Addendum No.: 1

Date Of Addendum: 09/07/18

Master Plan Phase III Renovations and Additions
Norwalk Community College
188 Richards Ave.
Norwalk, CT
BI – CTC – 467

3 HOT WATER UNIT HEATER PIPING
MS.04 NOT TO SCALE

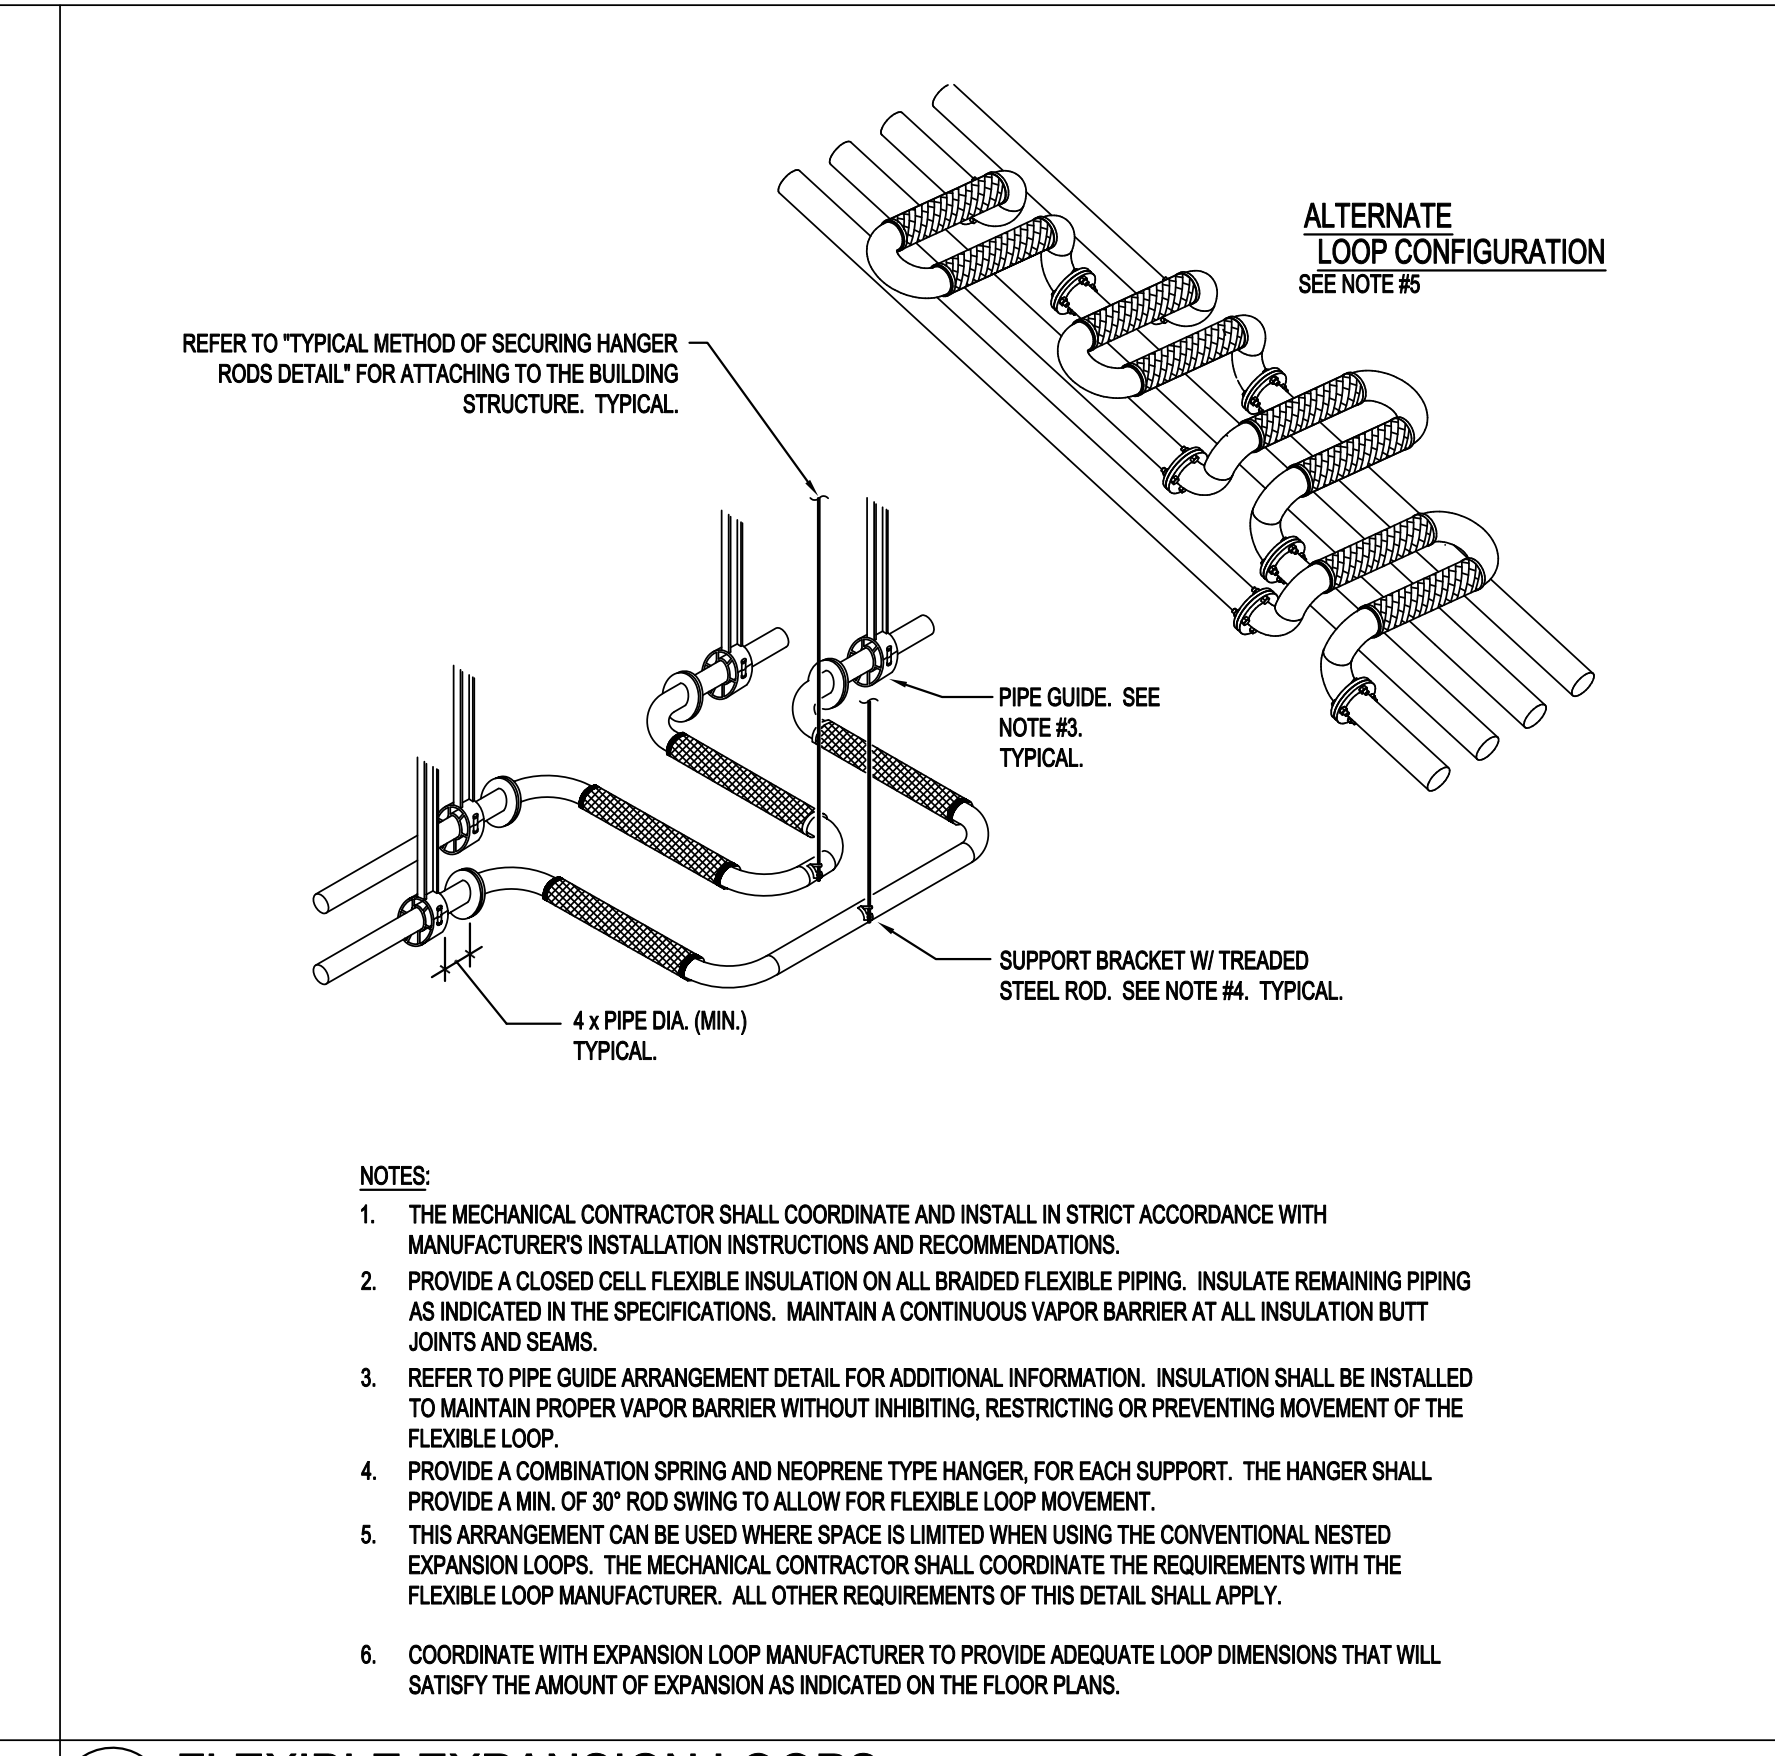
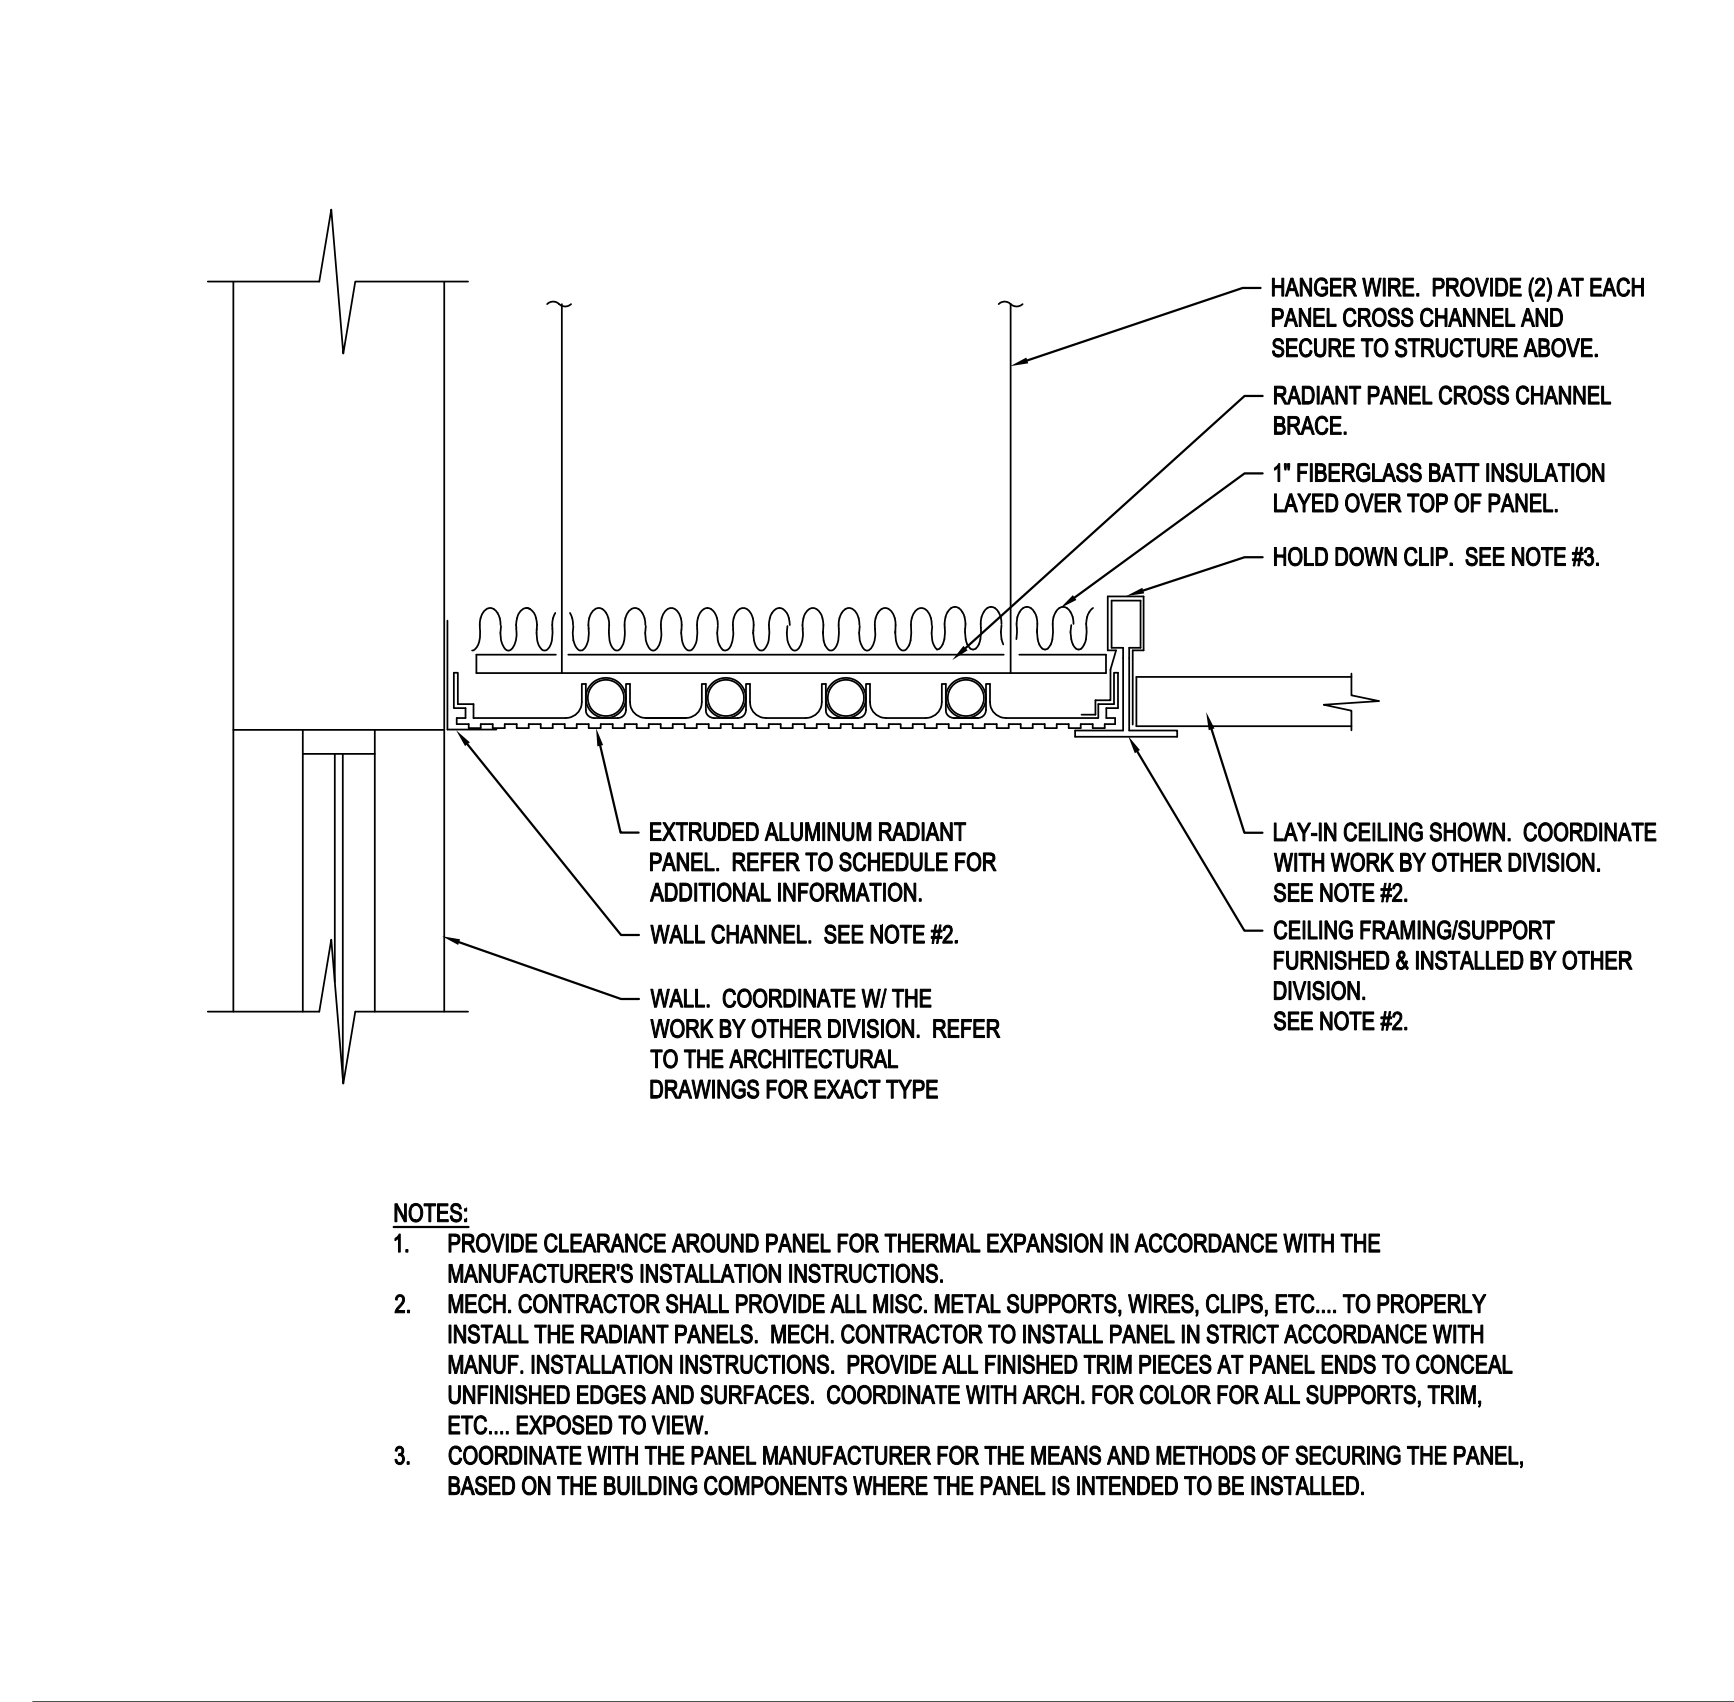
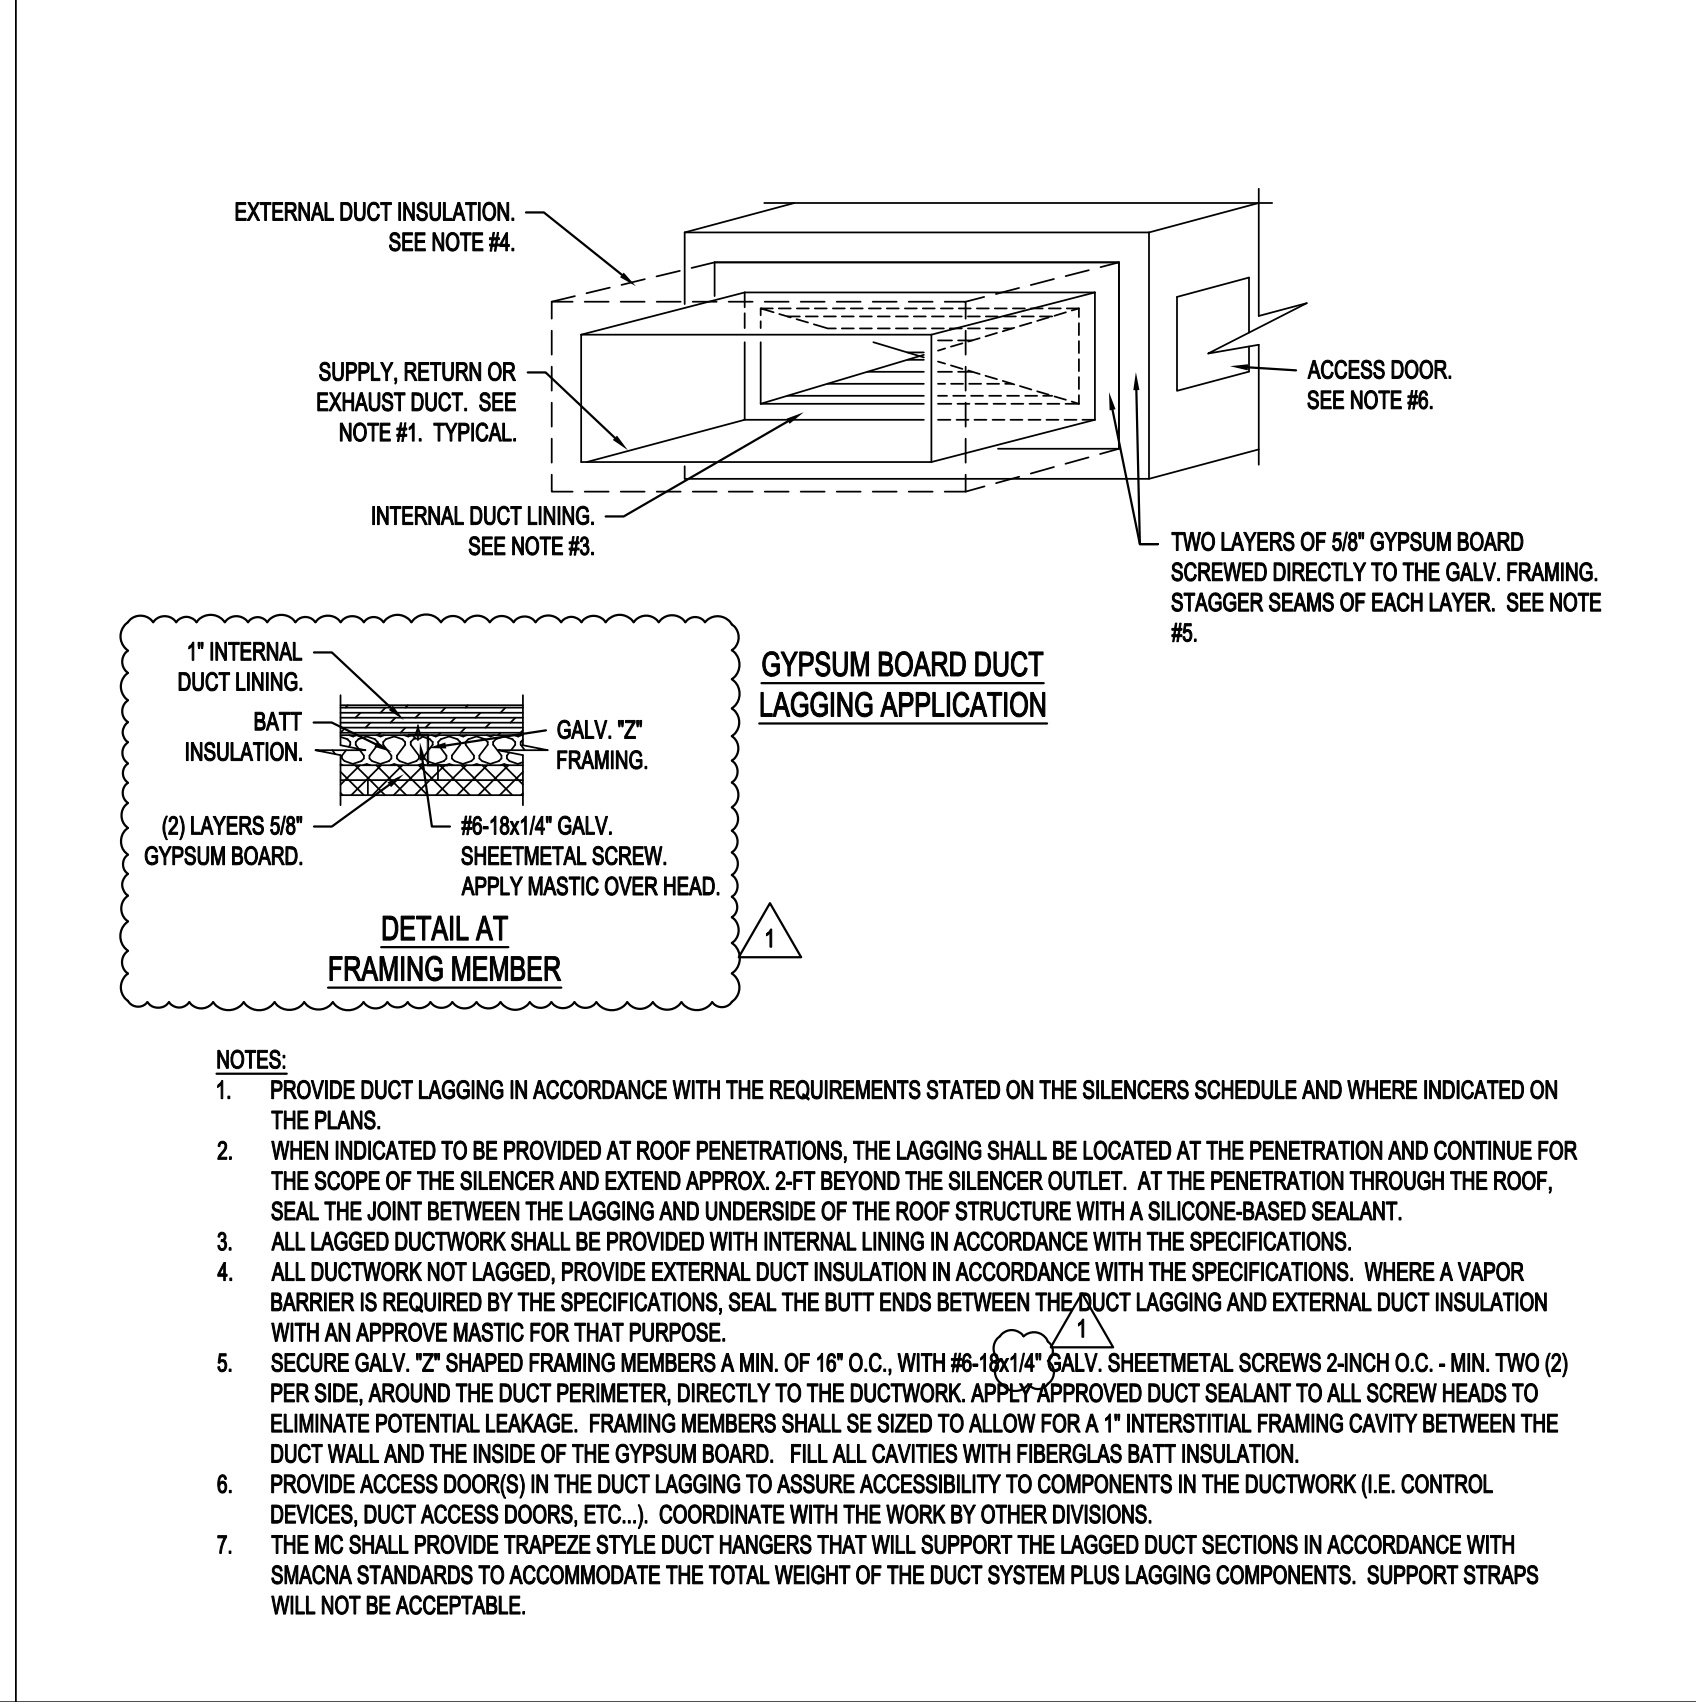
M5.04 – re-issued, Addendum No. 1, 09/07/18: Revised detail 11 to clarify VAV clearance requirements. Revised detail 7 to clarify duct lagging framing.
